**World Forum for Harmonization of Vehicle Regulations**

Working Party on General Safety Provisions

**Regulation No. 46 (Devices for indirect vision)****Proposal for a supplement to Regulation No. 46****Submitted by the expert from the Netherlands\***

Figure 7:  
 Field of vision of Class IV wide-angle mirrors **Class IV field of vision**

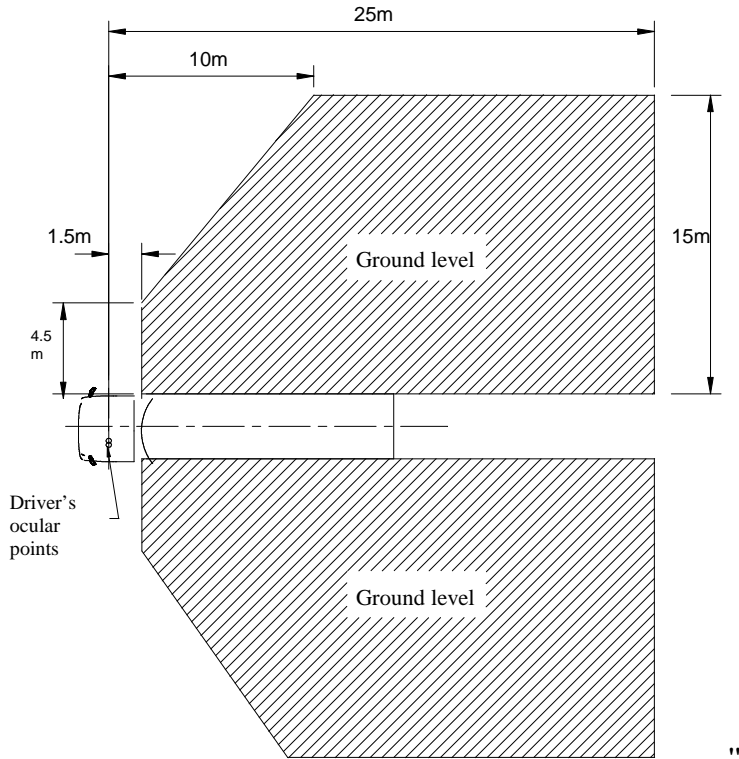
15.2.4.4.1. **Field of vision** ~~exterior mirror~~ on the driver's side  
The field of vision ... driver's ocular points (see Figure 7).

15.2.4.4.2. **Field of vision exterior mirror** on the passenger's side  
 The field of vision ... driver's ocular points (see Figure 7).

34. Align the text with the new definition of classes (para. 2.4.). Figure 7 has been corrected on the passenger's side so that the indicated dimensions are in correspondence with the front of the grey area.

"Figures 8c and 8d:  
Larger field of vision on the passenger side

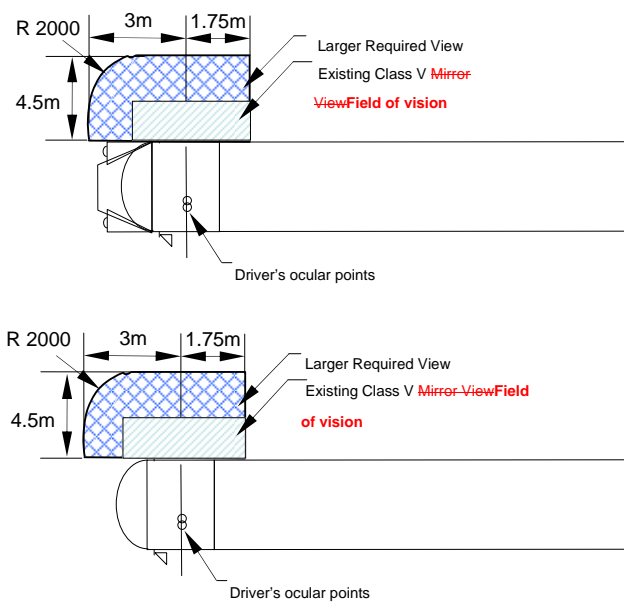
Paragraph 15.2.4.5.6., Figures 8c and 8d, amend to read:
